THE CITY OF SAN DIEGO

ENVIRONMENTAL IMPACT REPORT

Project No. 360009
SCH No. 2014071065

SUBJECT: MERGE 56 (AKA MERGE 56 DEVELOPMENT PROJECT): The project is comprised of two project components, a mixed-use development and public roadway improvements. The Mixed Use Development Component would require a GENERAL PLAN AMENDMENT from Commercial Employment, Retail and Services; Residential; and Parks, Open Space and Recreation to Multiple Use; a COMMUNITY PLAN AMENDMENT (CPA) to redesignate the site from Commercial Regional (CR) and Medium High Density Residential to Local Mixed Use (LMXU) within the Torrey Highlands Subarea Plan; a REZONE from Regional Commercial (CR-2-1) and Multi-family Residential (RM-3-9) to Community Commercial (CC-3-5) and Residential Small Lot (RX-1-2); a PLANNED DEVELOPMENT PERMIT (PDP) to amend PDP No. 53203; a SITE DEVELOPMENT PERMIT (SDP) to amend SDP No. 53204; a CONDITIONAL USE PERMIT (CUP) to allow a cinema/theater greater than 5,000 square feet in size; and a VESTING TENTATIVE MAP (VTM) to amend VTM No. 7938 to resubdivide from 3 lots to ~~400~~ 107 lots (84 Residential Small Lot zoned lots, ~~seven~~ 12 Community Commercial zoned lots, ~~five~~ seven

Figure 2-2

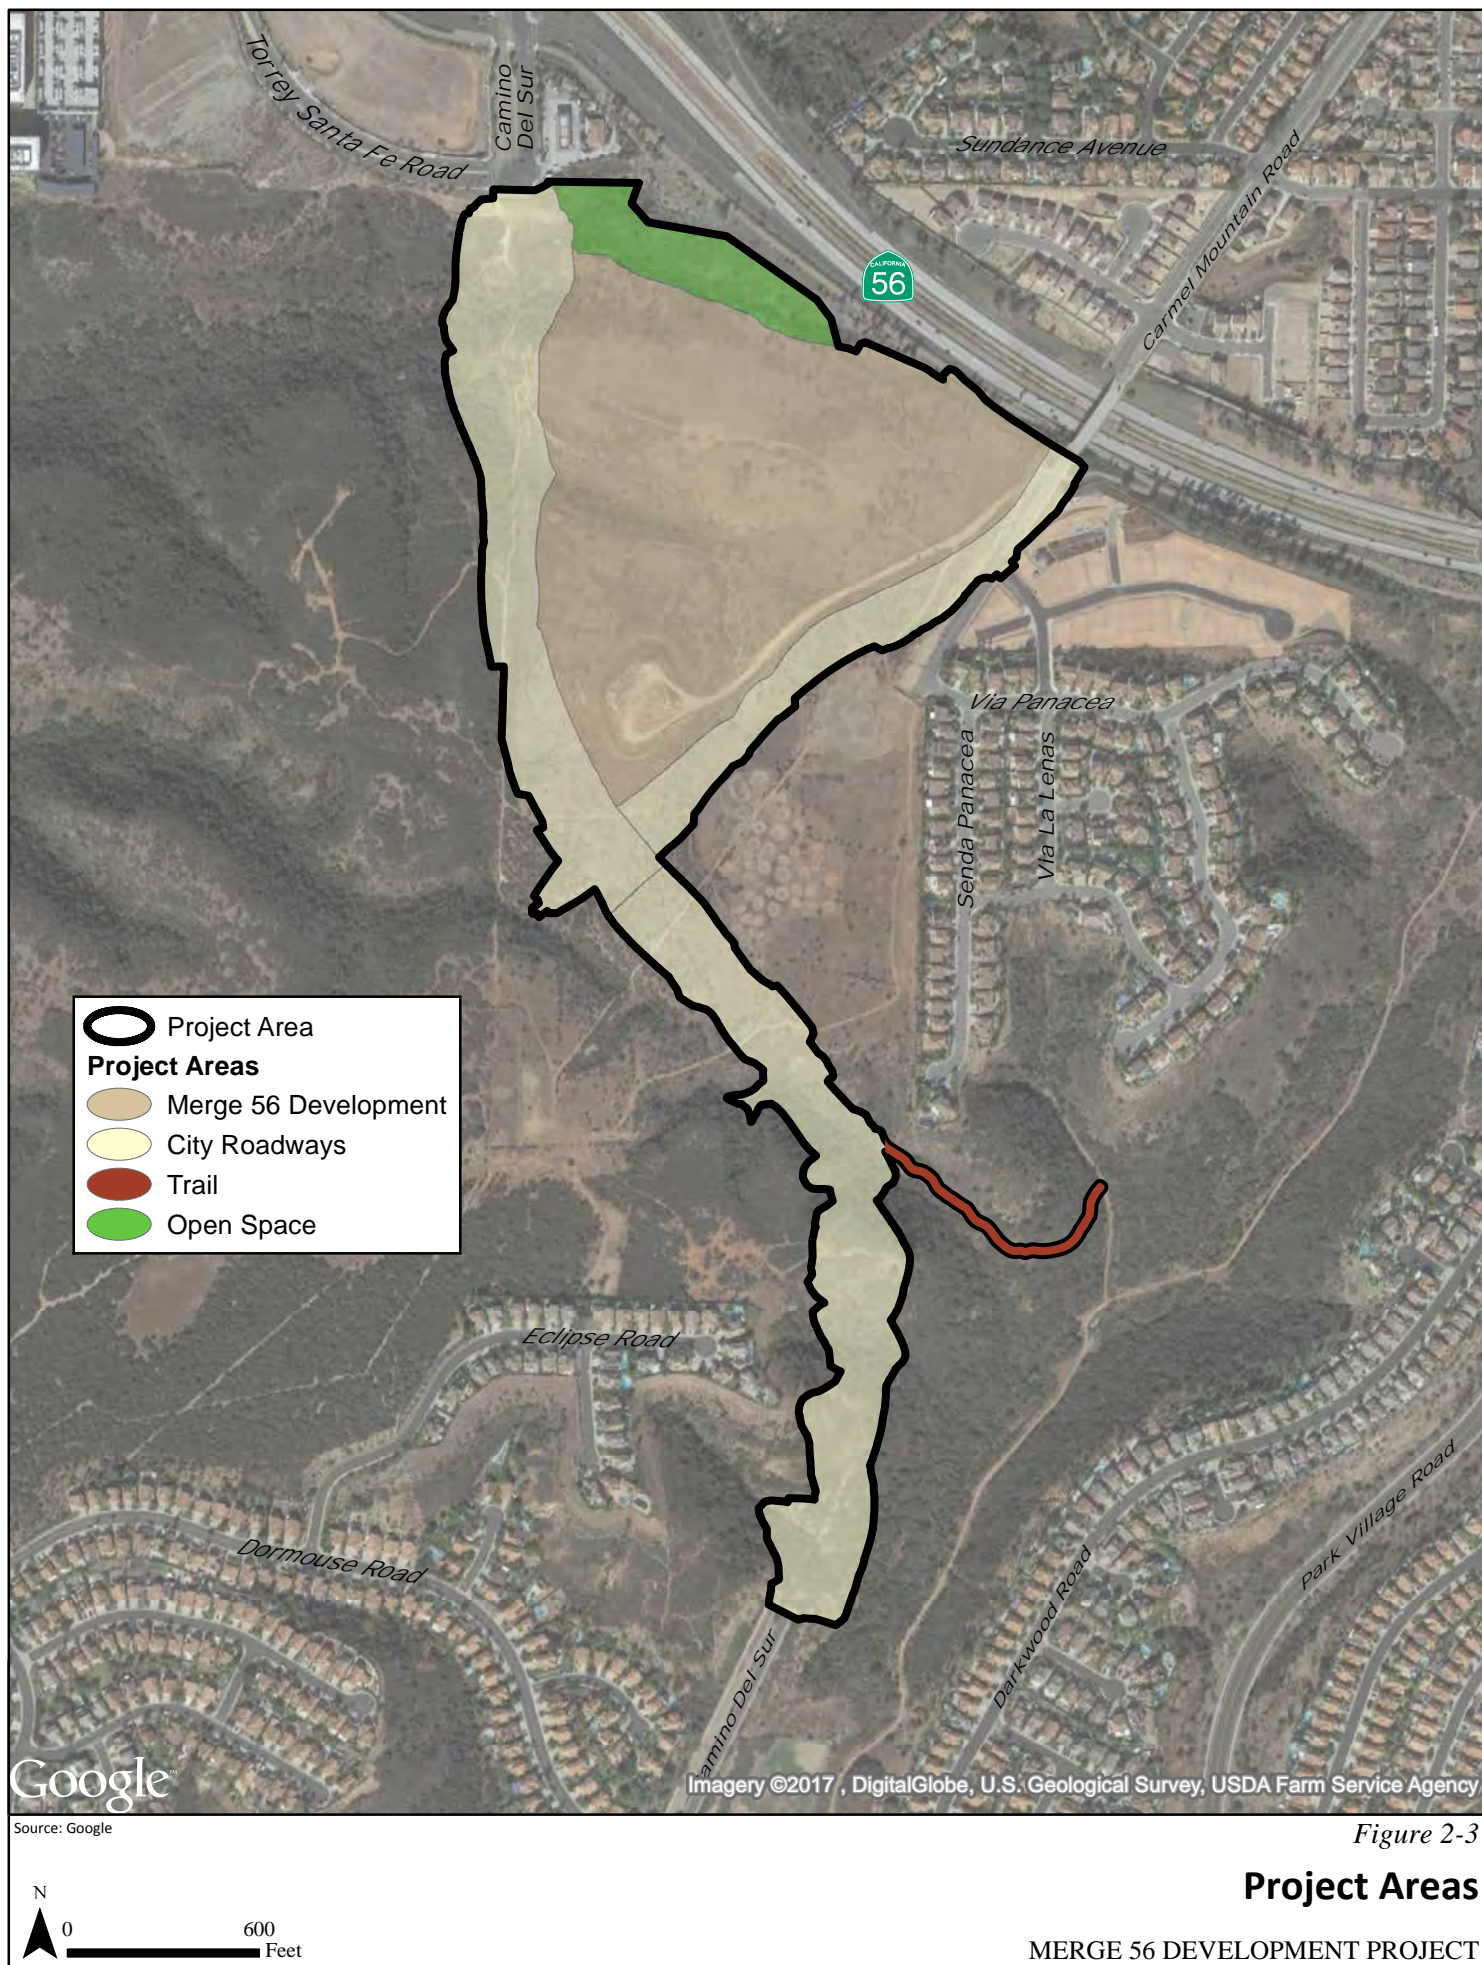
7. Figures 2-2, 2-3, 2-6, and 3-1: These figures inaccurately indicate that the project area extends onto Refuge land. As discussed above, all direct impacts to Refuge lands during and following construction of the proposed development shall be avoided. In addition, Figures 2-6 and 3-1 incorrectly identify the area within the MHPA as "proposed MSCP preserve." These figures should be revised to indicate that the majority of the lands shown in green are already part of the MHPA.

- B10** The text referenced in this comment is introductory and supplemented by more detailed information on ownership within Del Mar Mesa MHPA contained in Draft EIR Section 2.4.7, Carmel Mountain and Del Mar Mesa Natural Resource Management Plan. The information about the nature of surrounding properties that is requested in the comment has been integrated into Section 2.2 of the Final EIR. The MHPA and Refuge boundaries were shown in Figure 5.3-1a of the Draft EIR. The boundaries of the Refuge lands have also been added to Figure 2-2 in the Final EIR.

Figure 3-2

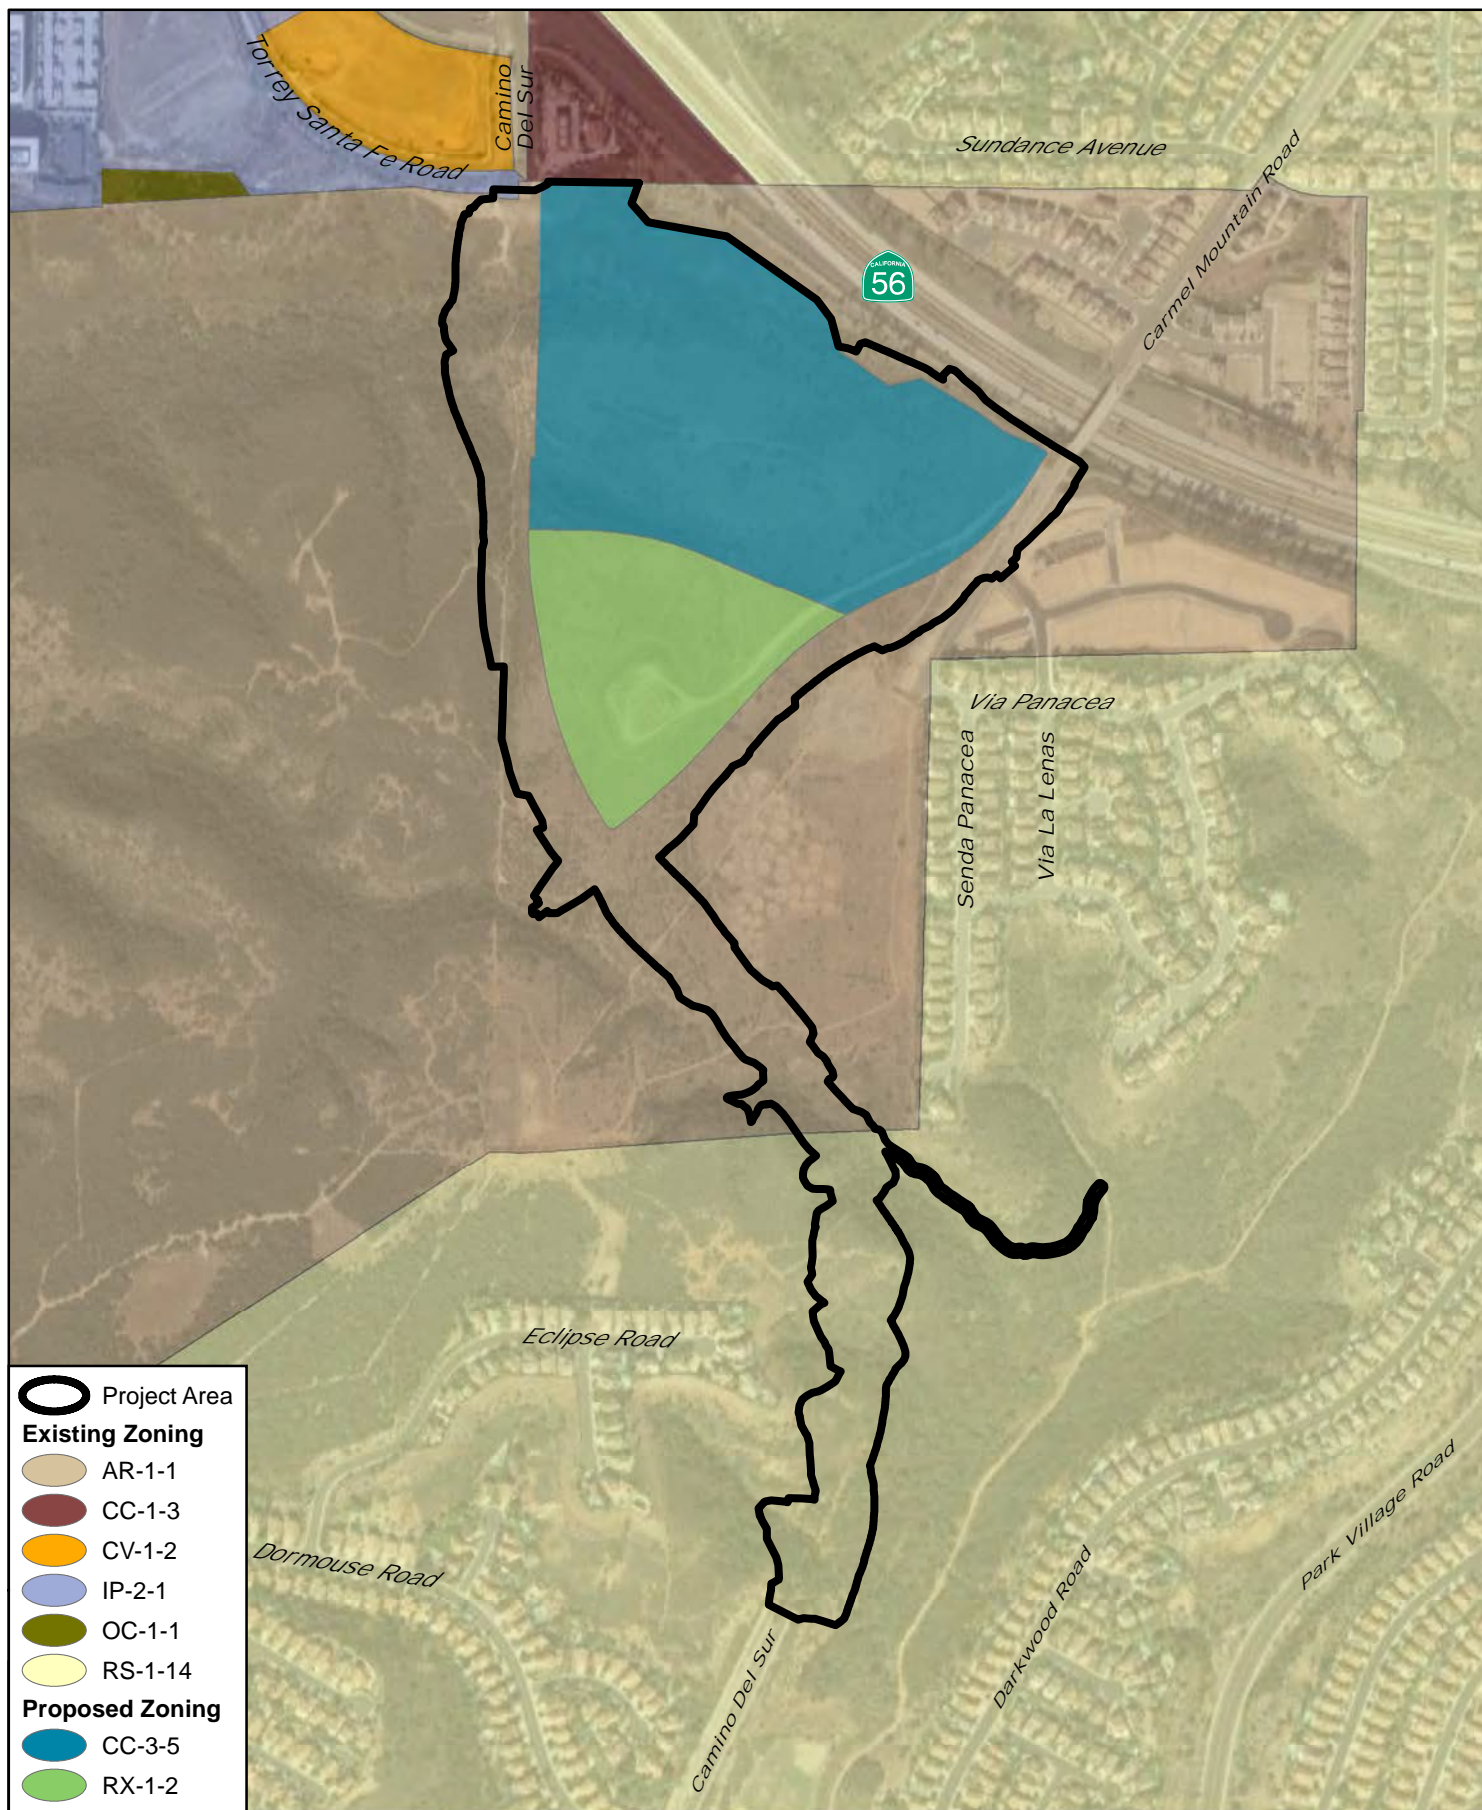
- N1 [1. Figure 3-2, Proposed Zoning, inaccurately represents the existing zoning for of the remaining Rhodes Crossing VTM parcels. We request this be corrected per Rezone Ordinance No. O-19273 adopted on April 12, 2004 for the Rhodes Crossing Project.
- N2 [2. Figures 2-2 and 3-3 appear to inaccurately depict how the MHPA line abuts Rhodes Crossing Lot 8. Although it is difficult to tell without a direct CAD overlay of Figures 2-2 and 3-3 onto the Rhodes Crossing VTM, the MHPA line depicted in them appears to overlap onto the Rhodes Crossing Lot 8 development area. We request that this be reviewed by the City and corrected as appropriate.
- N3 [3. Figure 5.3-3 shows the Darkwood Canyon to Del Mar Mesa Wildlife Corridor cutting through Rhodes Crossing development Lots 3 and 8. This needs to be corrected. This wildlife

- N1 The purpose of Figure 3-2 is to show the proposed zoning for the Merge 56 project site; modifications to the figure to adjust/update zoning on off-site parcels are not required by CEQA.
